**COUNTY OF SAN MATEO  
PLANNING AND BUILDING DEPARTMENT**

**SUBJECT:** Consideration of a Design Review Permit and Non-Conforming Use Permit, pursuant to Sections 6565.3 and 6137 of the San Mateo County Zoning Regulations, to allow the construction of a 571 sq. ft. single-story addition, new 331 sq. ft. deck, and a 41 sq. ft. entry porch to an existing 1,307 sq. ft. single-family residence on a 7,540 sq. ft. parcel. The project involves only minor grading and no tree removal.

County File Number: PLN2023-00051 (Gawoski)

**NEW ROOF PLAN**

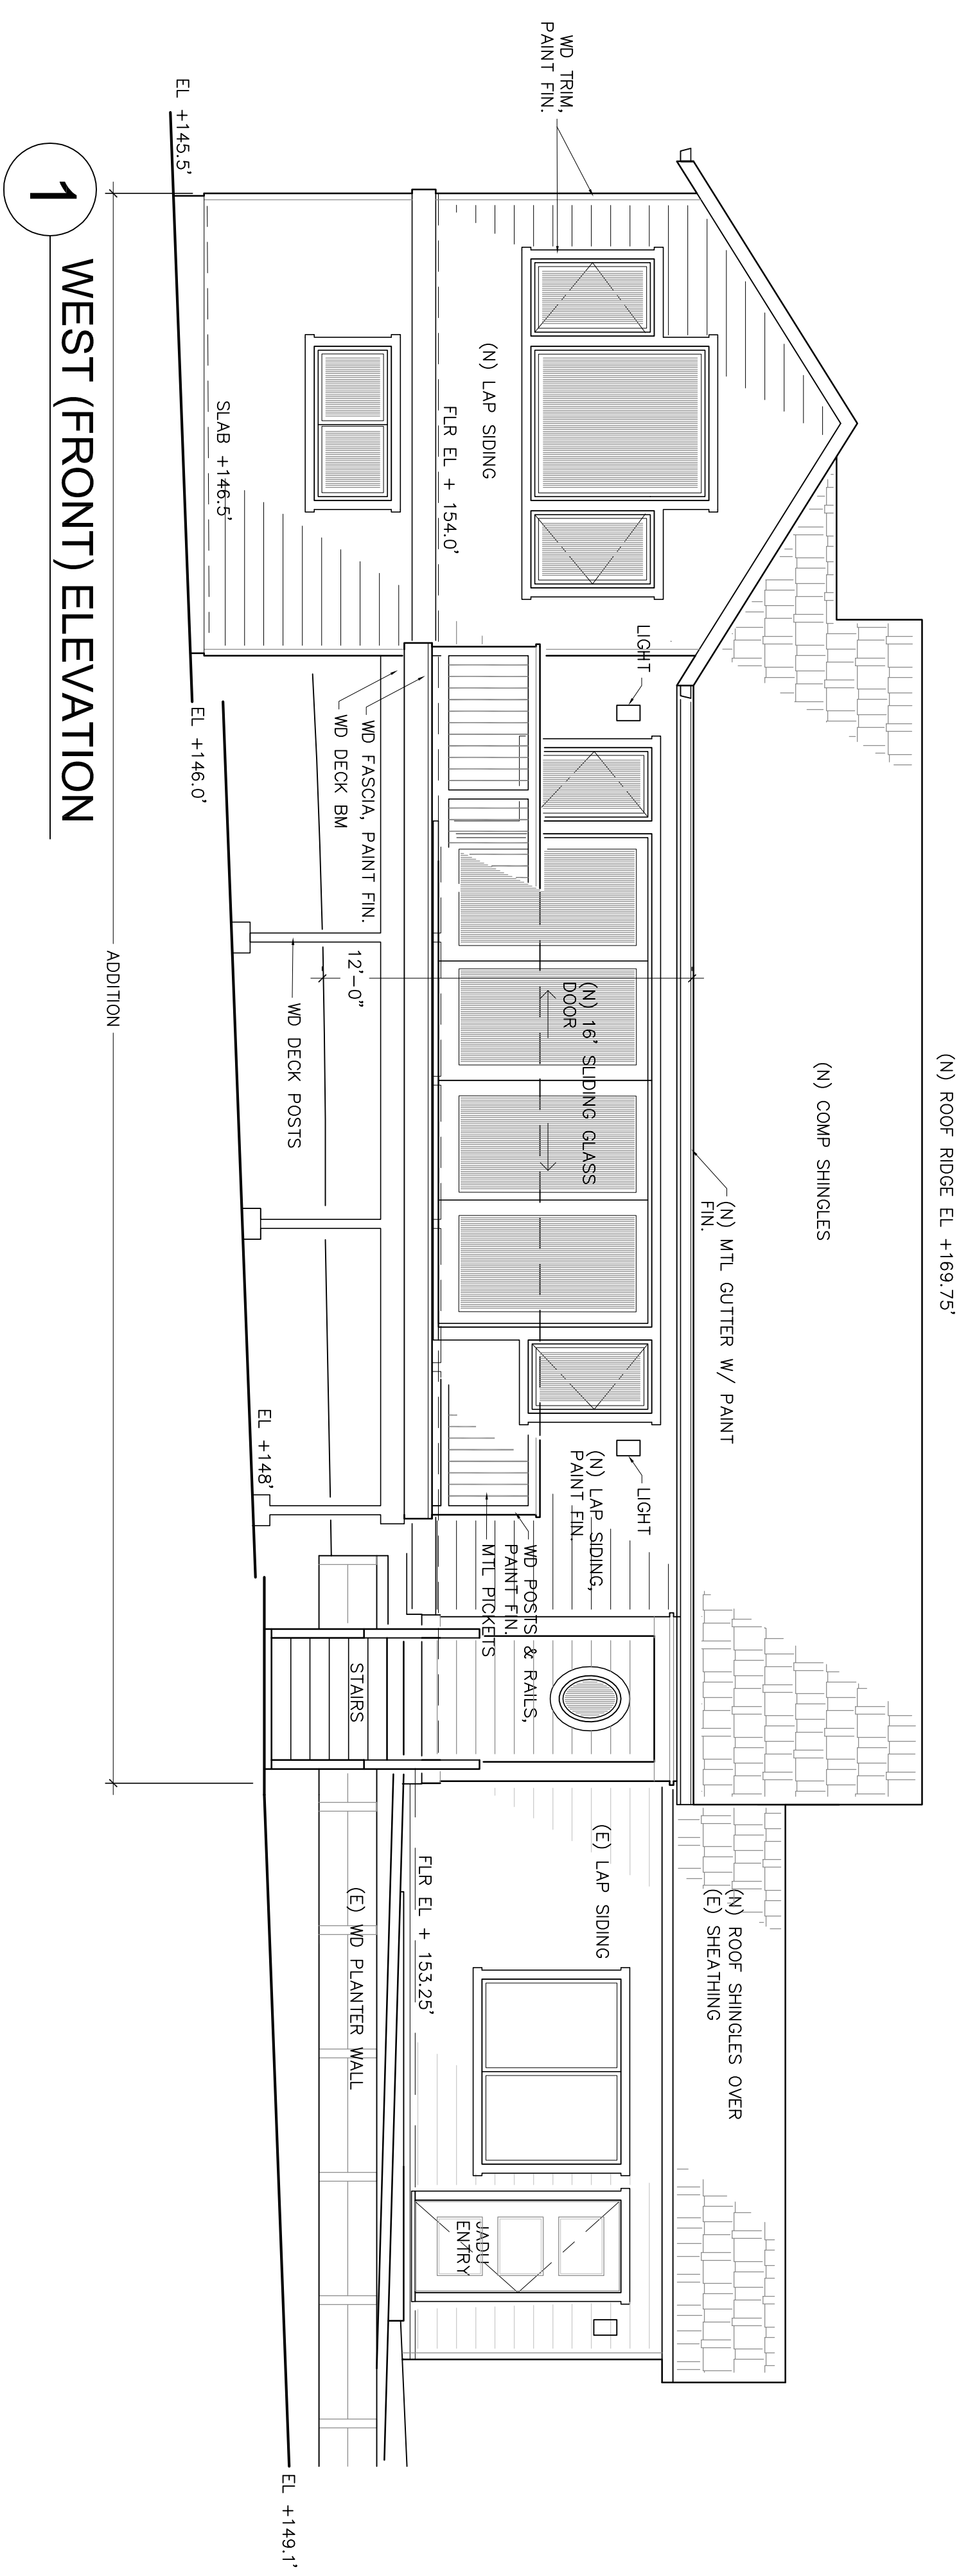
5. The CDRC also made the following suggestion for the applicant to consider regarding potential modification to improve the project:
  - a. Modify the existing roof design to match the existing roof slope and/or change the gable roof slope to match the 4:12 ratio of larger roof.
